# Access Compliance Report

## Public Rights-of-Way

Intersection ID: 25829	Main Street: GREYSON RIDGE DR	Cross Street: HIGH RIDGE RD	Location: NW
ADA ID: 5B51972B0E29	Ramp Type: PerpDiag	Initial Pass/Fail: Fail	Overall Compliance: No
Severity Score: 22.5			
Codes/Mitigation Info/Possible Solution		Field Measurements/Component Compliance

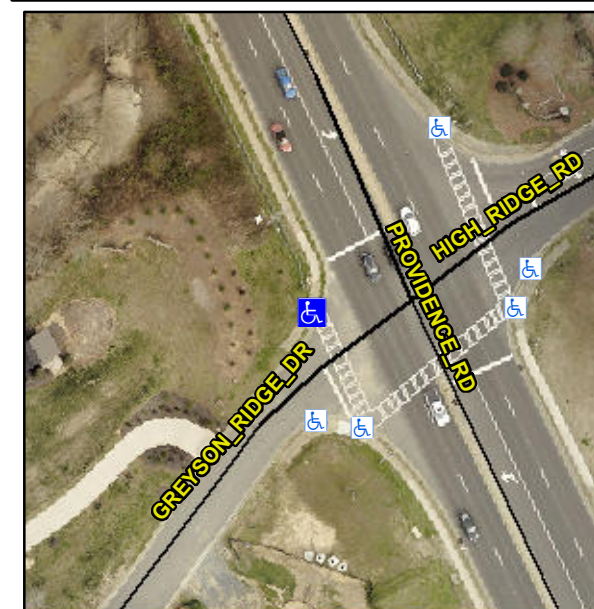
**Not Found, R304.5.1, R304.2.2**

Compliance	Description	Data	Compliance	Description	Data
N/A	Ramp Length (in)	83.0	No	Ramp Slope (%)	8.9
No	Ramp Width (in)	41.5	Yes	Ramp XSlope (%)	3.7
N/A	Flare Type LT	N/A	N/A	Flare Type RT	N/A
N/A	Flare Slope LT (%)	N/A	N/A	Flare Slope RT (%)	N/A
N/A	Flare Traversable LT?	N/A	N/A	Flare Traversable RT?	N/A
N/A	Landing Length (in)	N/A	N/A	DWS Provided?	N/A
N/A	Landing Width (in)	N/A	N/A	DWS Contrast?	N/A
N/A	Landing Slope (%)	N/A	N/A	DWS Length (in)	N/A
N/A	Landing X Slope (%)	N/A	N/A	DWS Full Width?	N/A
N/A	Landing Curb? (Y/N)	N/A	N/A	DWS Offset (in)	N/A
N/A	Shared Landing?	N/A			
N/A	Gutter Ponding?	N/A	N/A	Gutter Slope (%)	N/A
N/A	Gutter Lip Ht (in)	N/A	N/A	Gutter X Slope (%)	N/A
N/A	Painted X Walk1?	Yes	N/A	Painted X Walk2?	No
	X Walk 1 Direction	To SE		X Walk 2 Direction	To NE
N/A	X Walk 1 Width (in)	80.0	N/A	X Walk 2 Width (in)	N/A
	X Walk 1 Slope (%)	4.1		X Walk 2 Slope (%)	1.4
	X Walk 1 X Slope (%)	2.6		X Walk 2 X Slope (%)	3.8

**Remove & Replace Curb Ramp With Two New Directional Ramps or Equivalent.**
